CHANGE ORDER

CHANGE ORDER NUMBER
3
4/18/2022
Page 1 of 10

<input checked="" type="checkbox"/> ORDERED BY ENGINEER UNDER SECTION 1-04.4 OF THE STANDARD SPECIFICATIONS. <input type="checkbox"/> CHANGE PROPOSED BY CONTRACTOR.	PROJECT IDENTIFICATION PROJECT NAME: North Creek Trail Phase 1 – SR524 to Sprague Drive PROJECT NUMBER: RC1776, RR6318, RR6323, RR6319, RC1798
CONTRACTOR ENDORSEMENT: <div style="display: flex; justify-content: space-between;"> SIGNATURE DATE </div> <hr/> <div style="display: flex; justify-content: space-between;"> PRINT NAME TITLE </div>	CONTRACTOR: Rodarte Construction, Inc. ADDRESS: 17 East Valley Hwy E Auburn, WA. 98092

This Change Order compensates the Contractor for added work required to grind and pave a full-width HMA overlay on Filbert Drive and Winesap Road adjacent to the North Creek Trail Phase 1 Project.

REFERENCE SHEET NO.
CH01
SHEET 124 OF 171 SHEETS

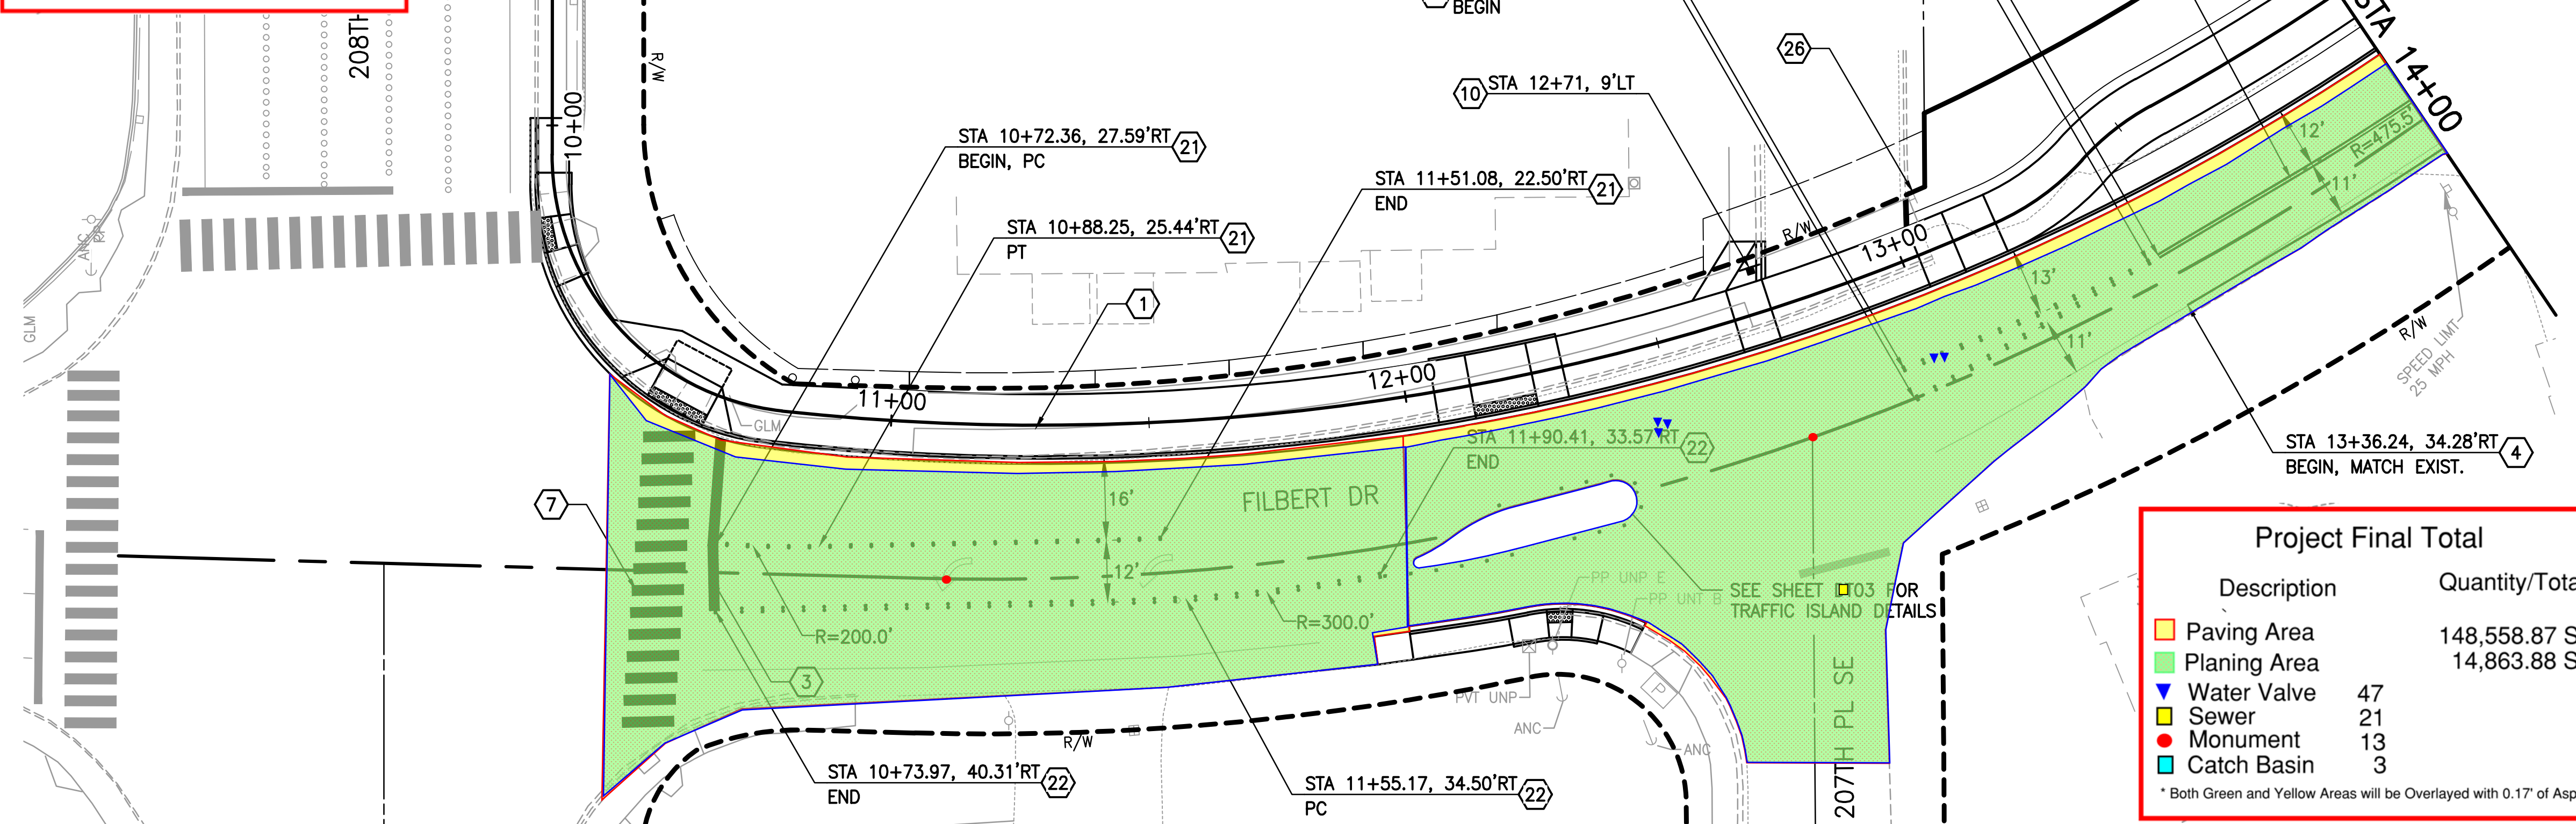
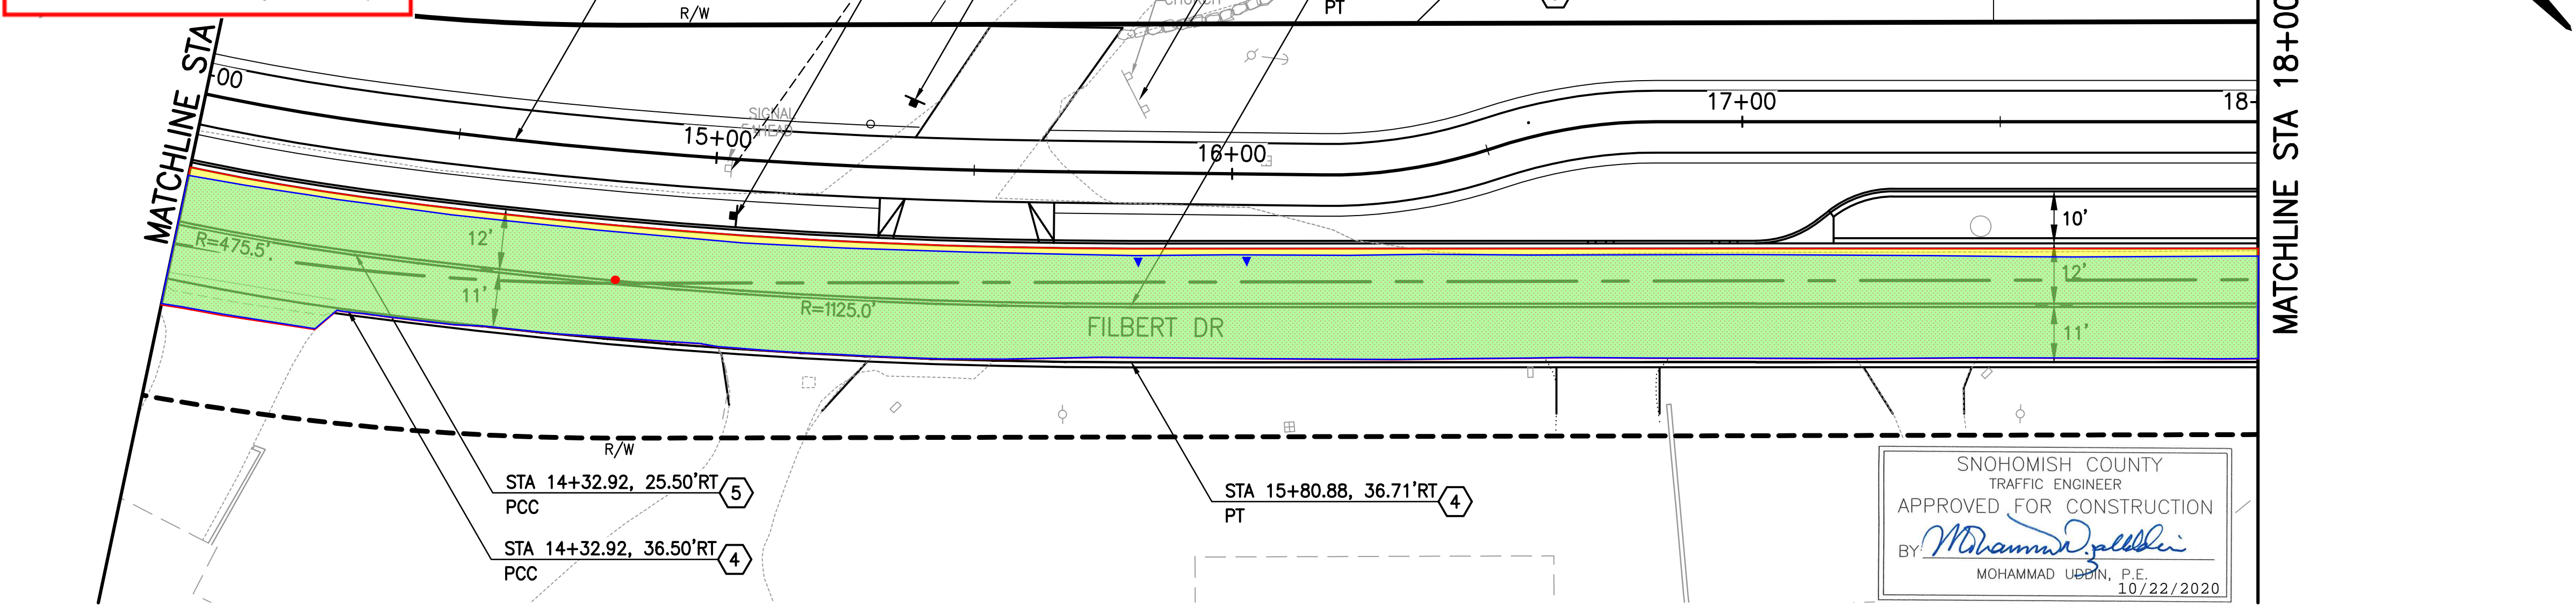
Legend This Section 11+00 - 14+00

Description	Quantity/Total
Paving Area	16,030.18 SF
Planing Area	1,692.35 SY
Water Valve	5
Sewer	1
Monument	2
Catch Basin	0

* Both Green and Yellow Areas will be Overlaid with 0.17' of Asphalt

Legend This Section 14+00 - 18+00

Description	Quantity/Total
Paving Area	8,887.41 SF
Planing Area	926.74 SY
Water Valve	2
Sewer	0
Monument	1
Catch Basin	0

* Both Green and Yellow Areas will be Overlaid with 0.17' of Asphalt

REFERENCE SHEET NO.
CH02
SHEET 125 OF 171 SHEETS

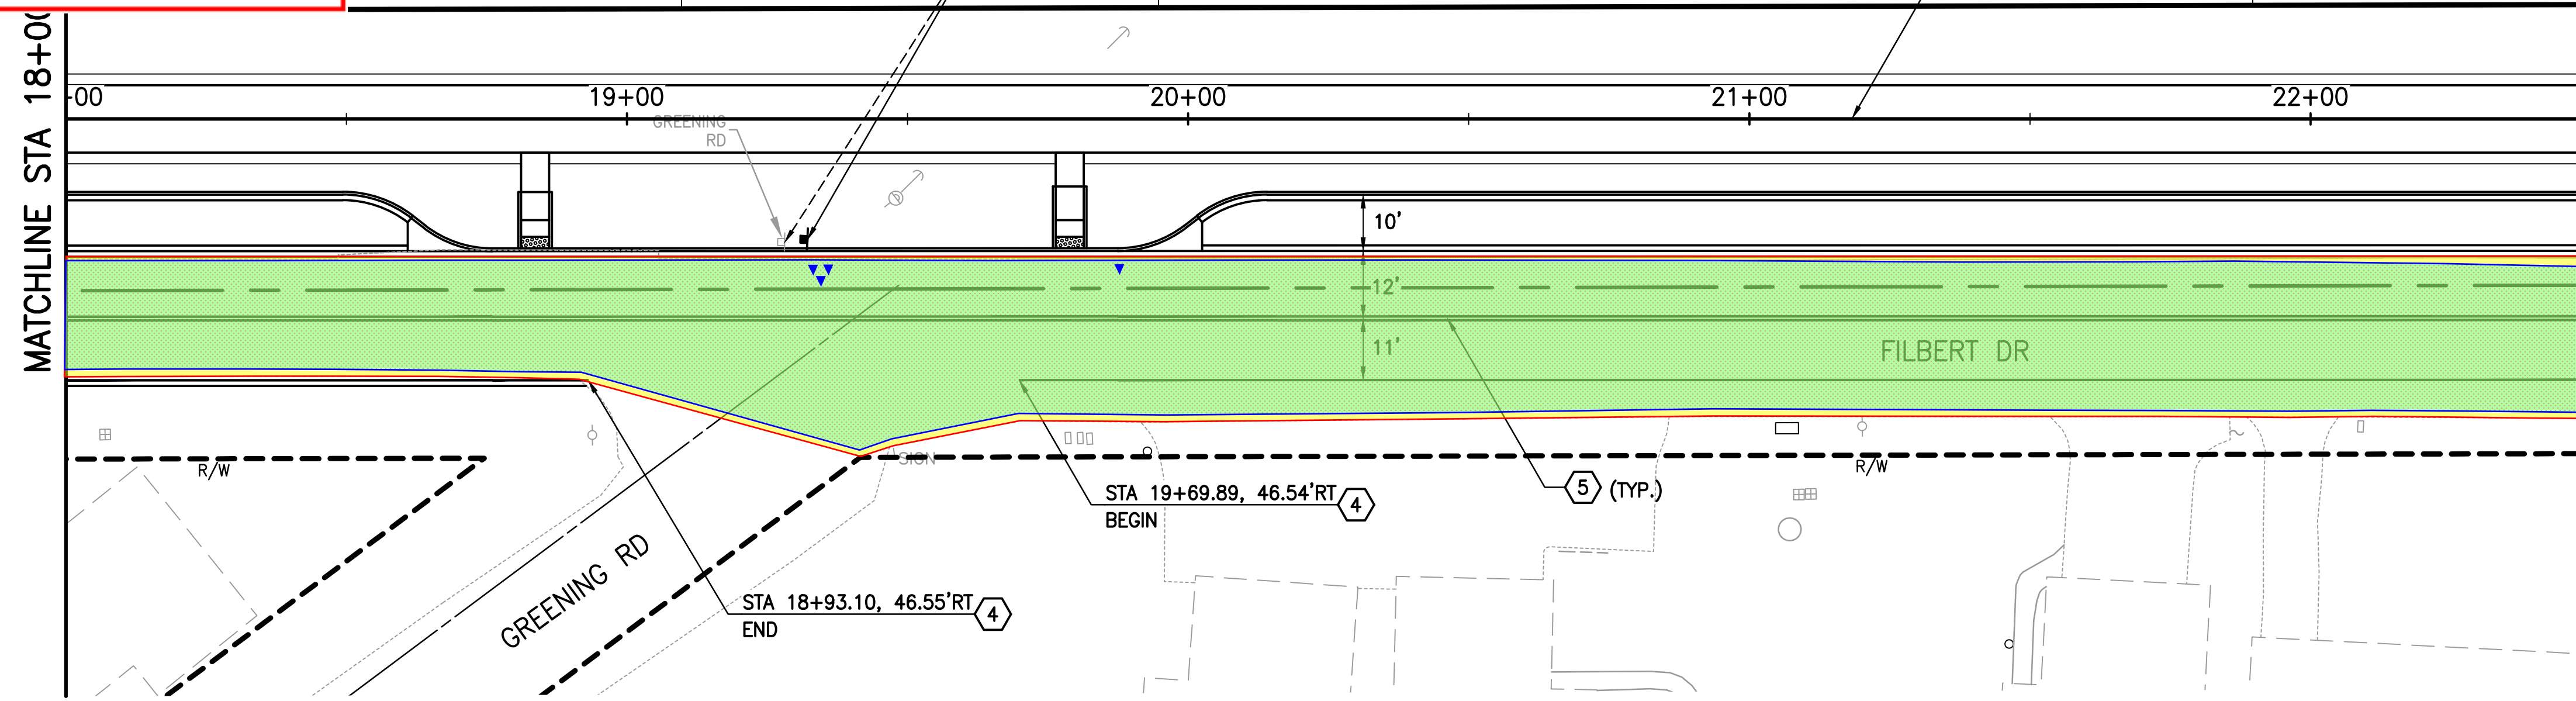
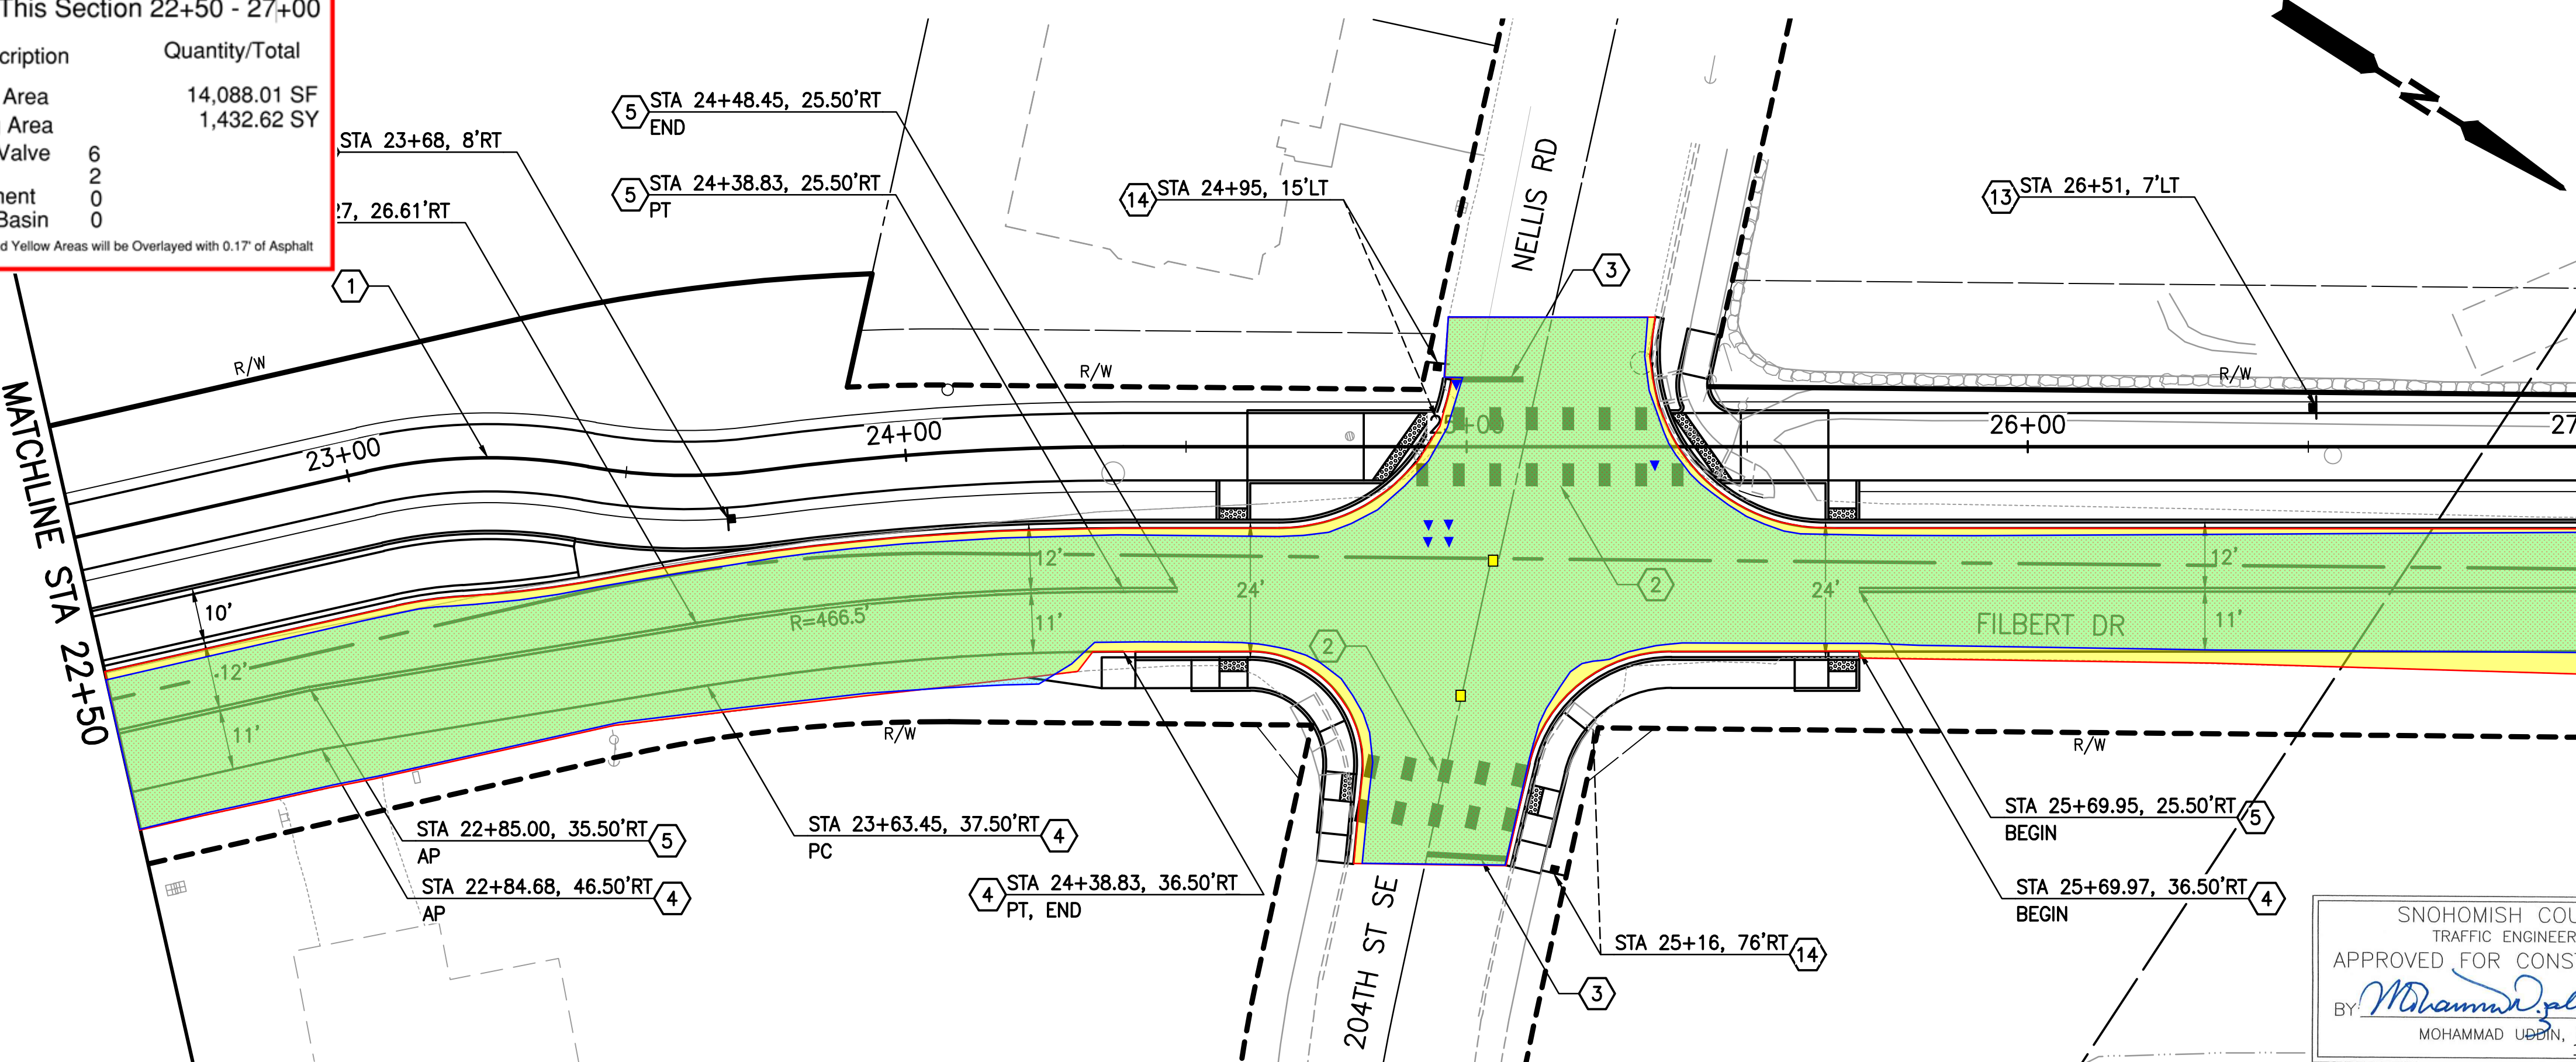
Legend This Section 18+00 - 22+50

Description	Quantity/Total
Paving Area	12,385.29 SF
Planing Area	1,275.08 SY
Water Valve	4
Sewer	0
Monument	0
Catch Basin	0

* Both Green and Yellow Areas will be Overlaid with 0.17" of Asphalt

Legend This Section 22+50 - 27+00

Description	Quantity/Total
Paving Area	14,088.01 SF
Planing Area	1,432.62 SY
Water Valve	6
Sewer	2
Monument	0
Catch Basin	0

* Both Green and Yellow Areas will be Overlaid with 0.17" of Asphalt
